Subject: RE: Departmental Comments_Planning Application No. A/YL-
PH/1013
Attachment: 2529CL04.pdf

**Planning Application (No. A/YL-PH/1013) for
Temporary Wholesale Trade (Food) for a Period of Five Years
Lot Nos. 872, 873, 875, 876, 877, 878, 880, 881, 882, 883, 884, 885, 886, 887, 888, 889,
890, 891 s.A, 892 s.A, 893 s.A, 3049 and 3050 in DD 111 and
Adjoining Government Land
Pat Heung, Yuen Long, New Territories**

We would like to respond to the departmental comments received on the captioned planning application as follows:-

Swept Path

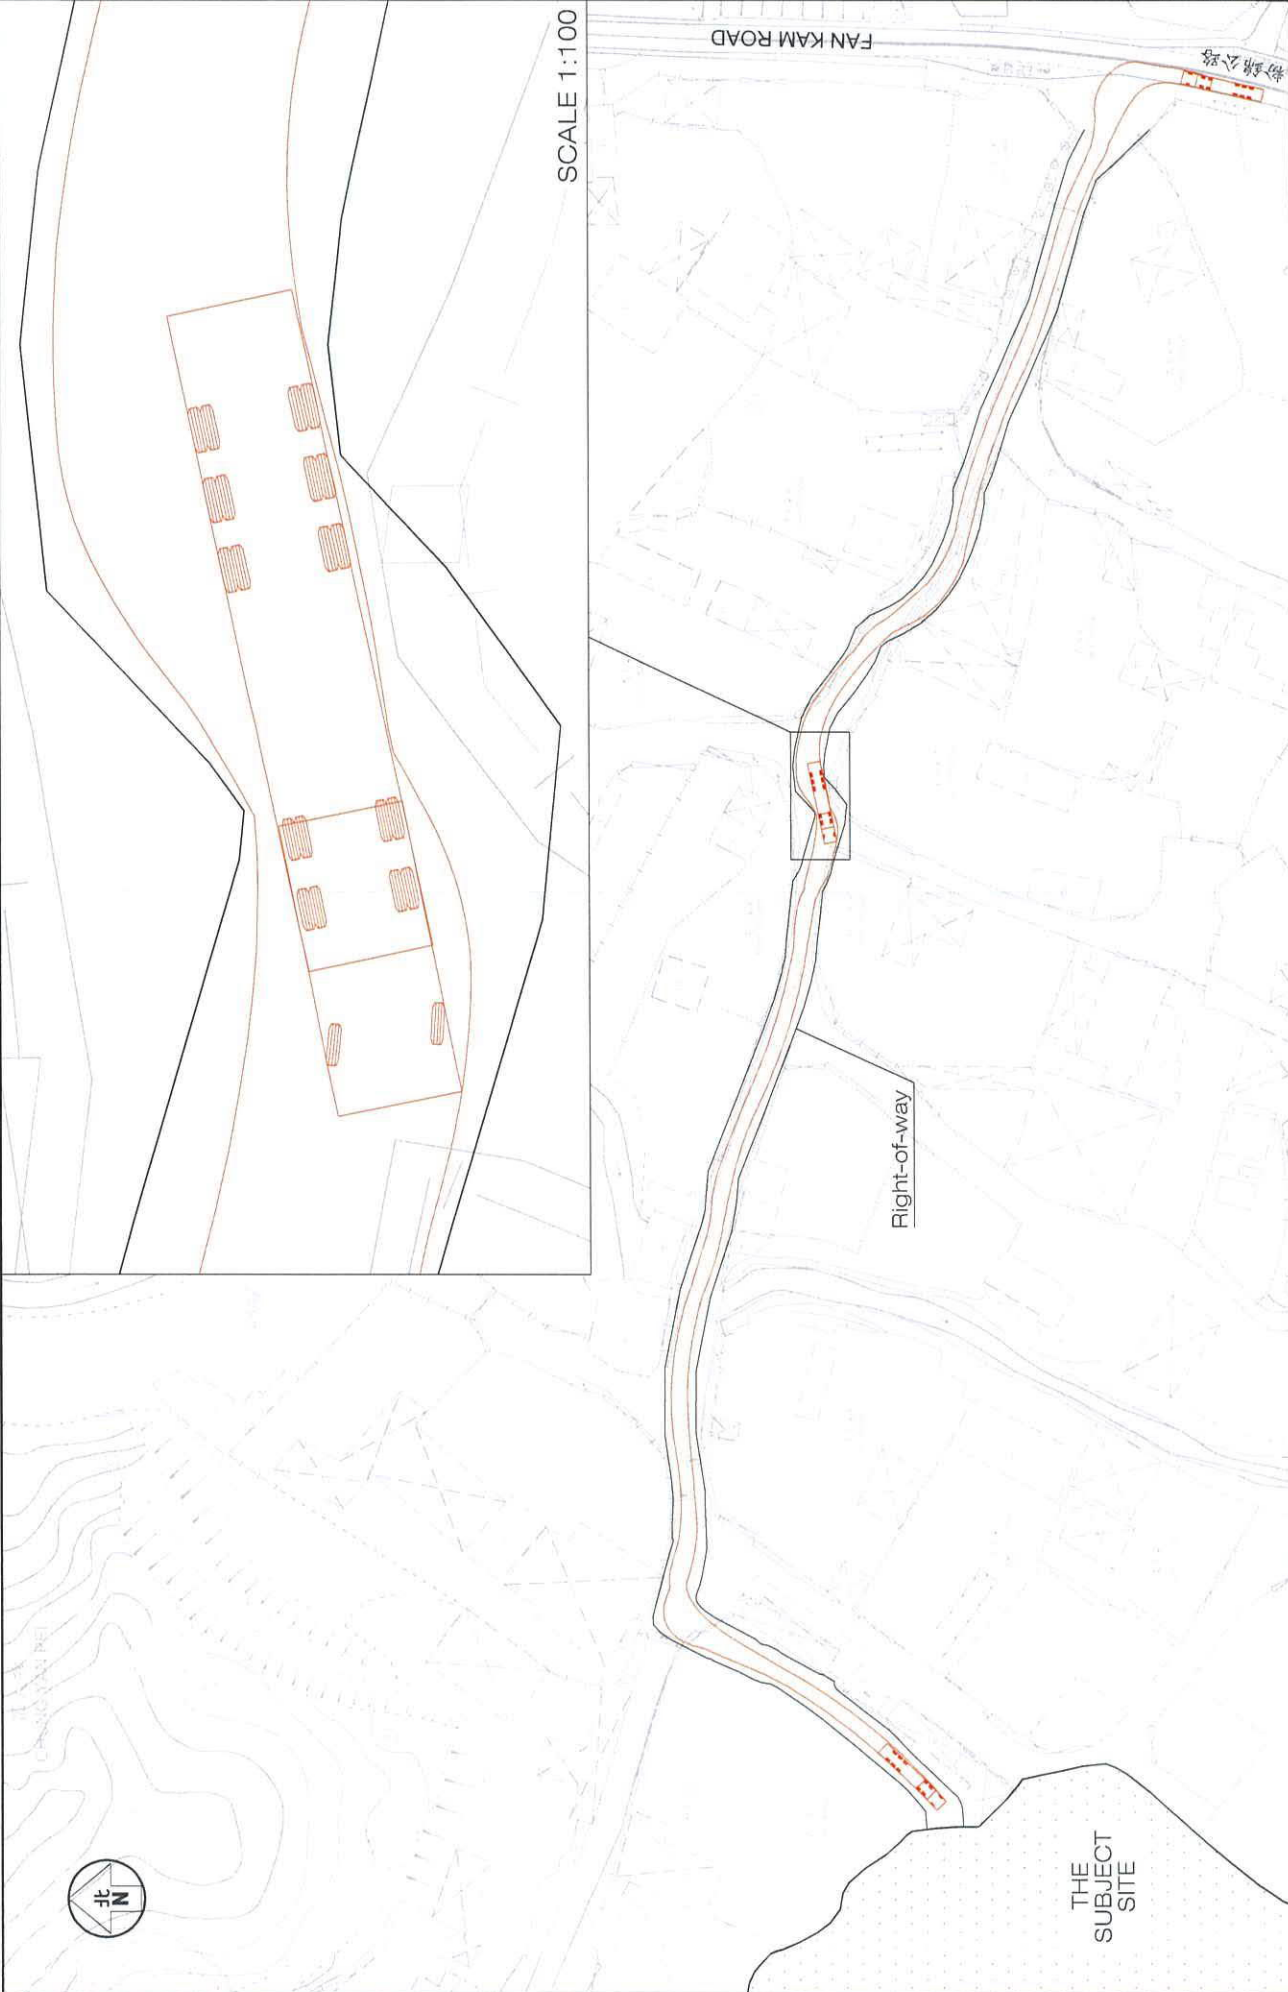
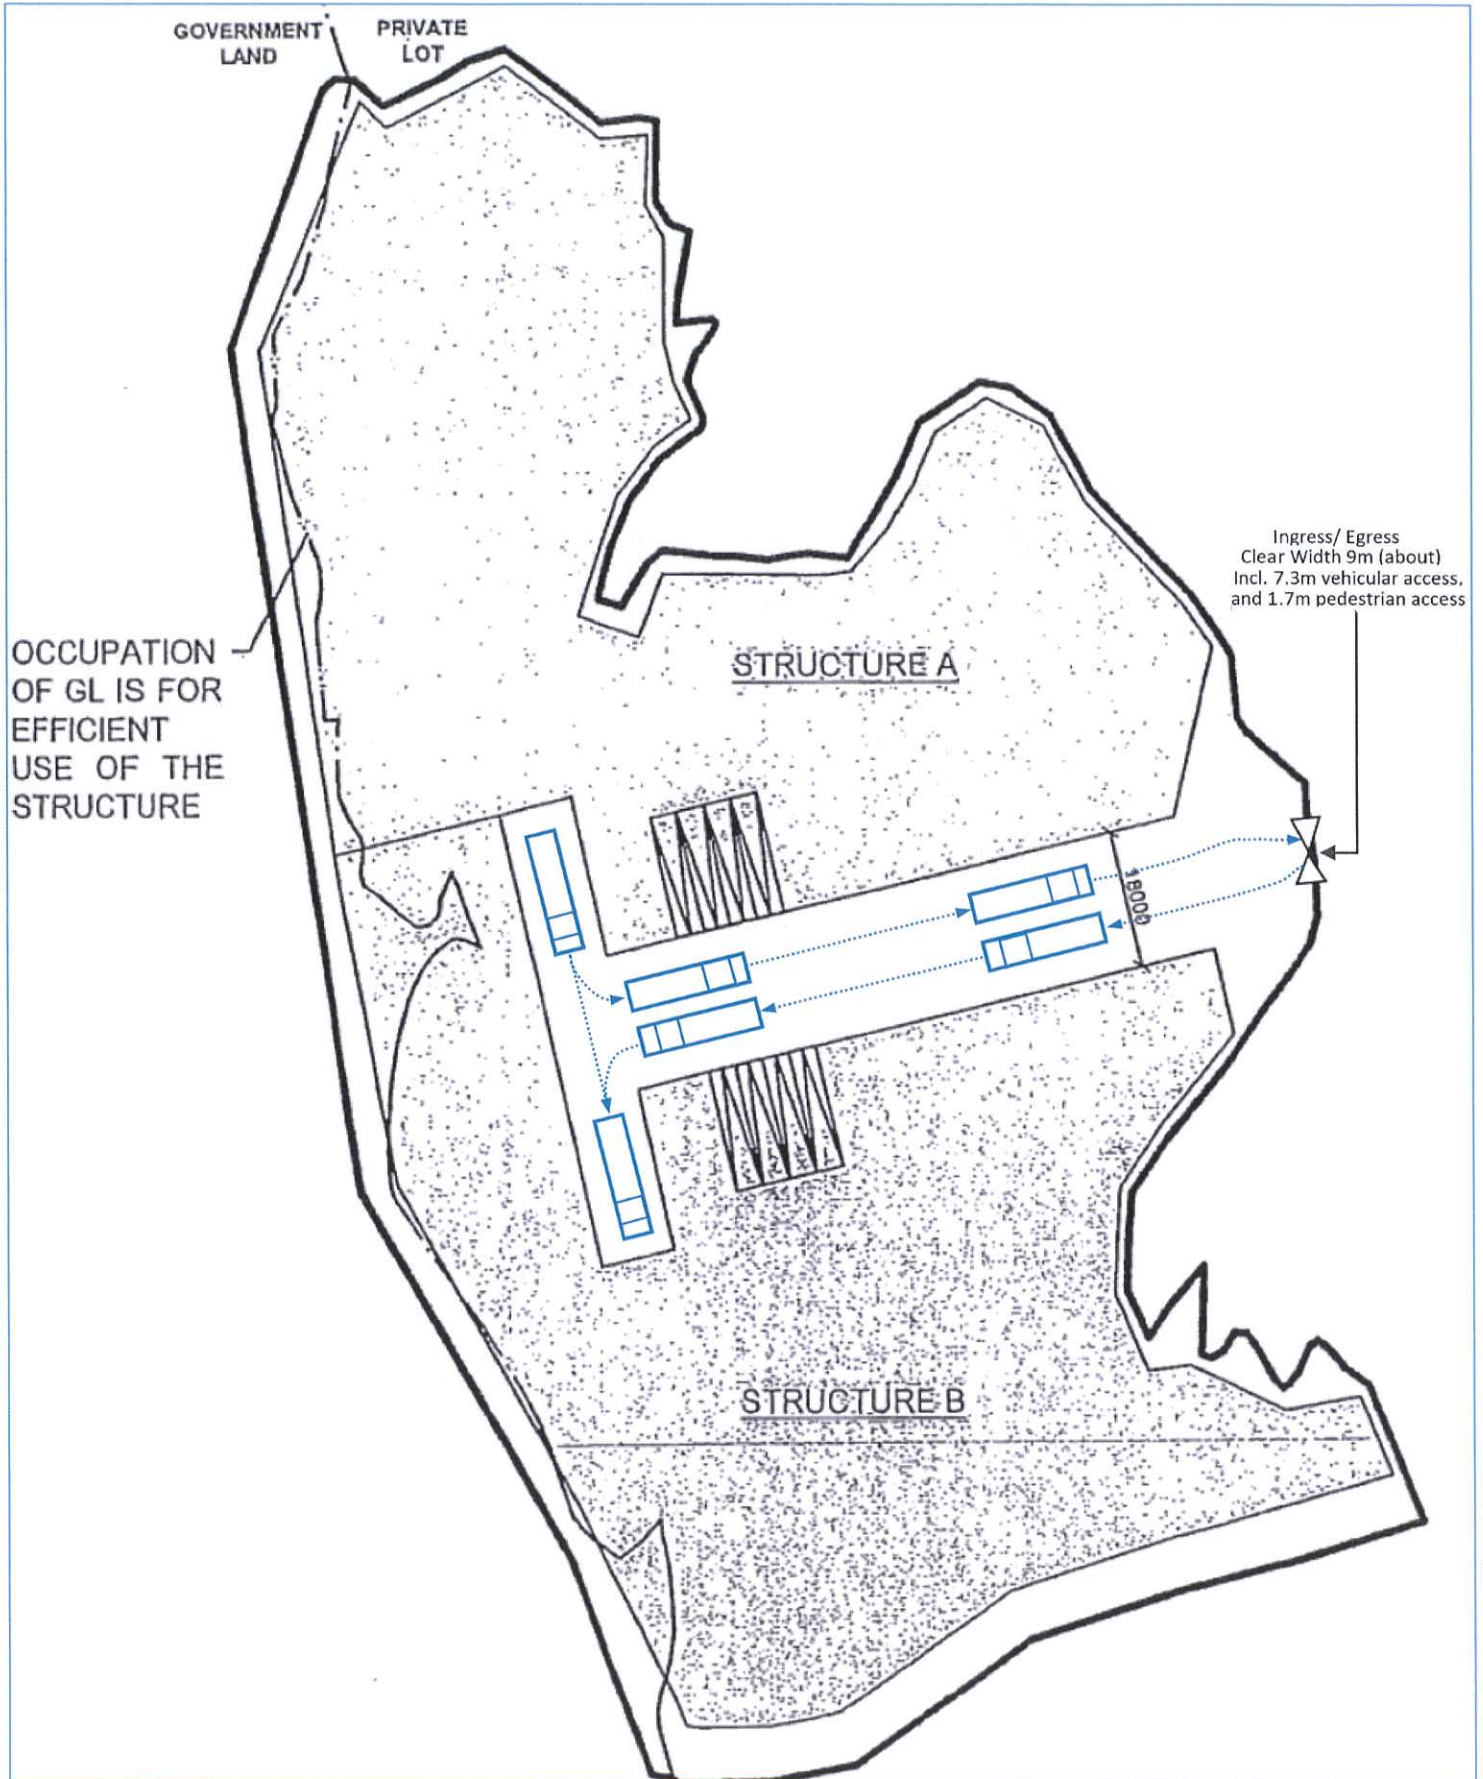
-	Transport Department	
(a)	The applicant should demonstrate the smooth manoeuvring of vehicles to / from Fan Kam Road, along the local access and within the site;	Please see the swept path along the local access and within the site at Appendix 1 .

Appendix 2
Revised layout plan

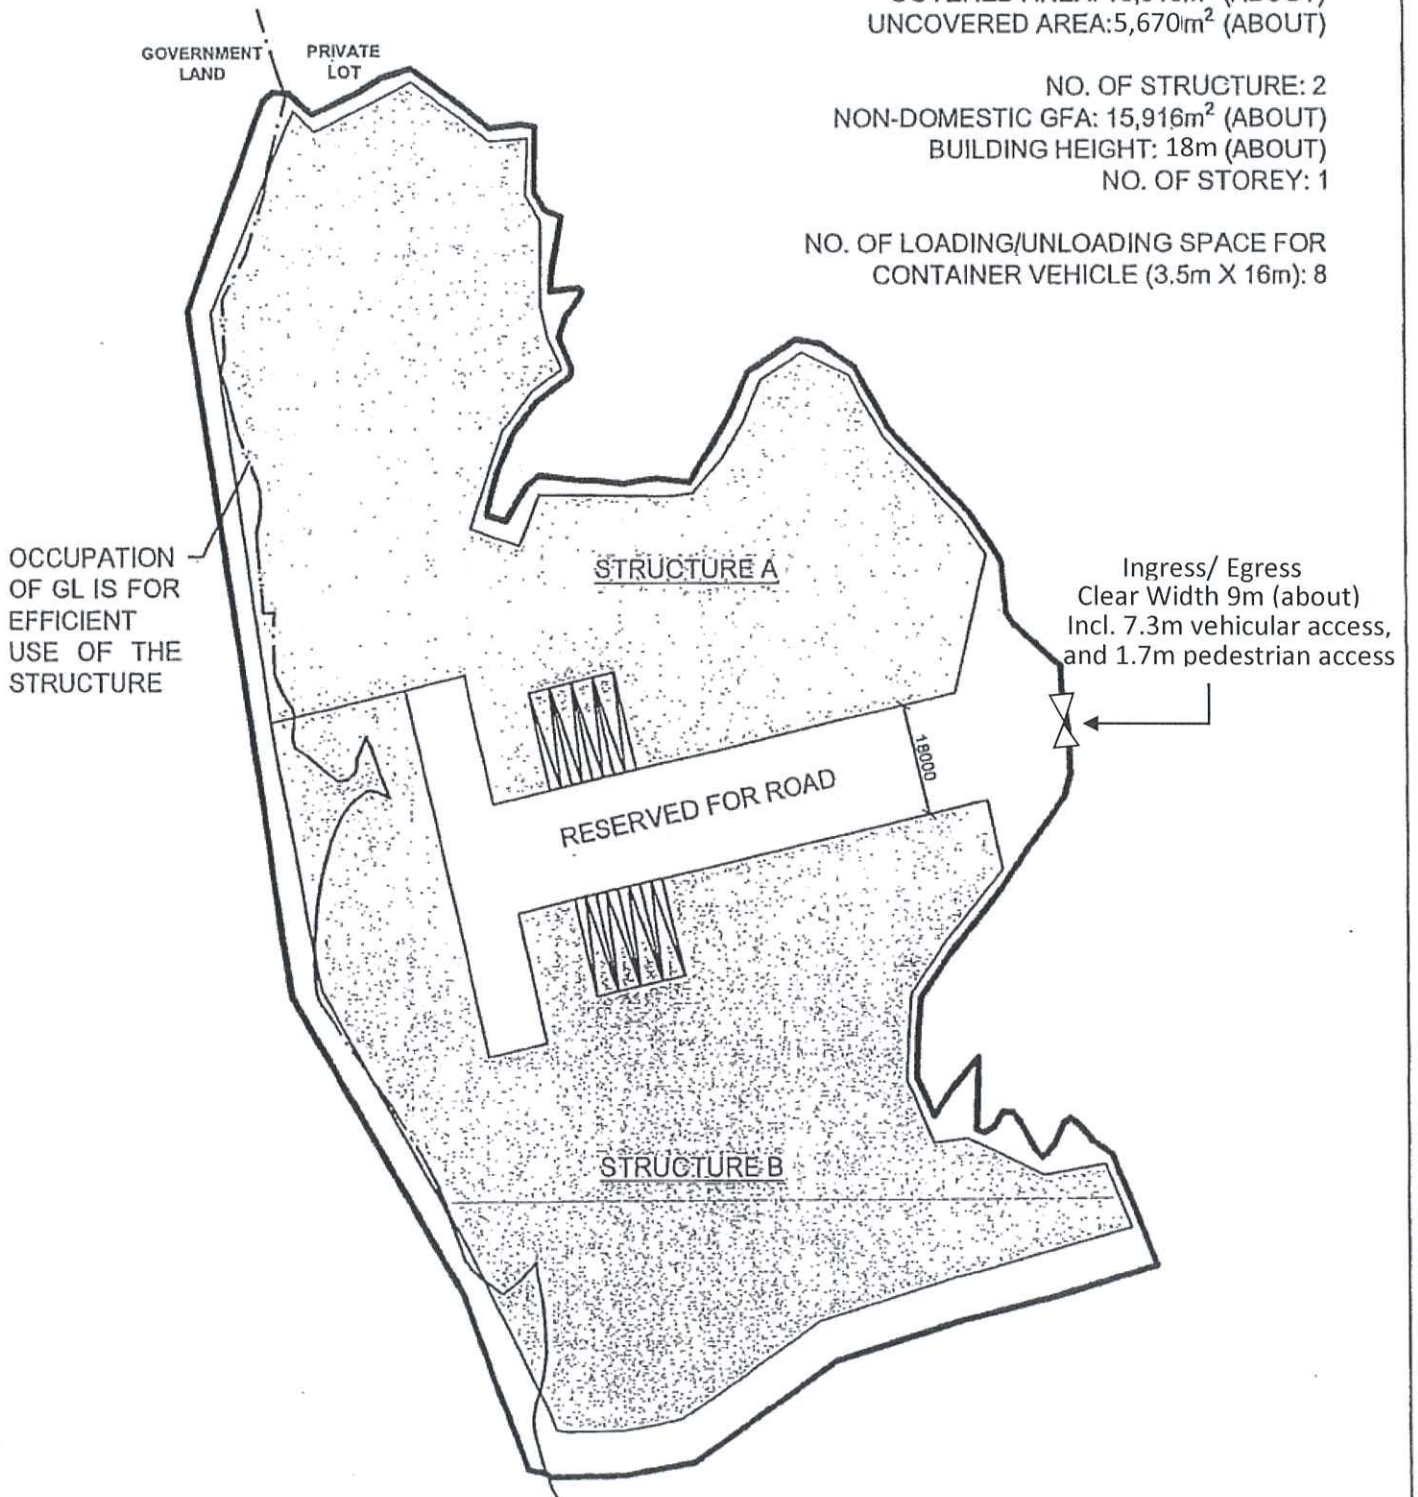
(b)	The applicant should indicate the clear width of the vehicular ingress / egress on the layout plan;	Please see the revised layout plan with the about 9m clear width of the ingress/ egress including 7.3m for vehicular access and 1.7m for pedestrian access at Appendix 2 .

Revised Fire Services Installation Proposal

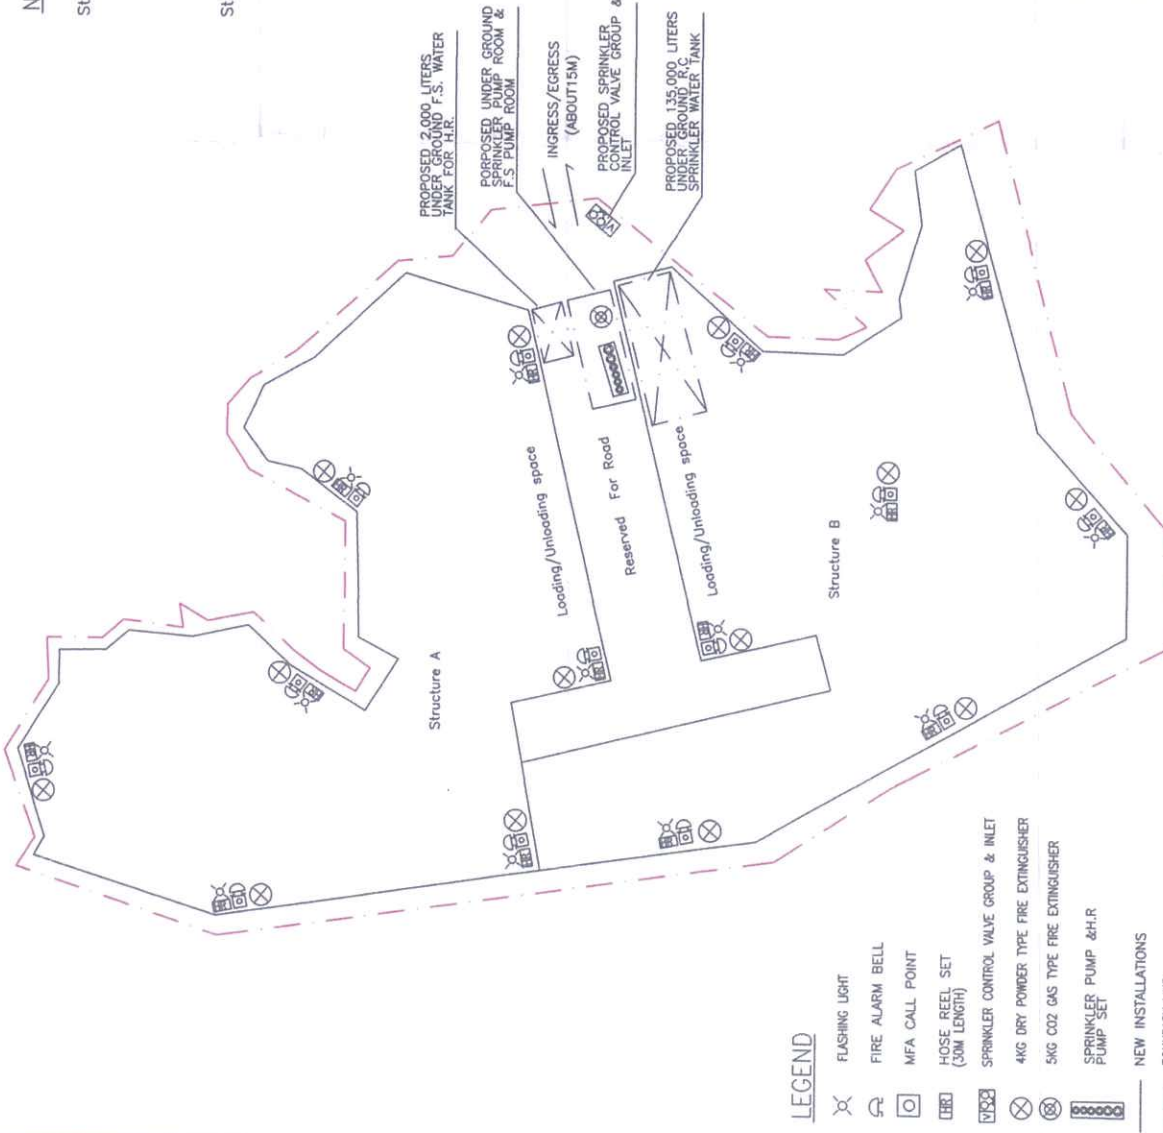
-	Fire Services Department	
(i)	The standards and specifications of the proposed emergency lighting shall be revised to "BS 5266-1:2016, BS EN 1838:2013 and the FSD Circular Letter No. 4/2021";	Please see the revised fire services installation proposal (revised fire notes no. 1) at Appendix 3 .
(ii)	The standards and specifications of the proposed fire alarm system shall be revised to 'BS 5839-1:2017 and the FSD Circular Letter No. 6/2021'; and	Please see the revised fire services installation proposal (revised fire notes no. 7) at Appendix 3 .
(iii)	Sufficient directional and exit signs shall be provided in accordance with BS 5266-1:2016 and the FSD Circular Letter No. 5/2008.	Please see the revised fire services installation proposal (revised fire notes no. 2) at Appendix 3 .

- Sufficient emergency lighting shall be provided throughout the entire building in accordance with BS5266-1:2016, BS EN 1838:2013 and FSD Circular Letter No. 4/2021.
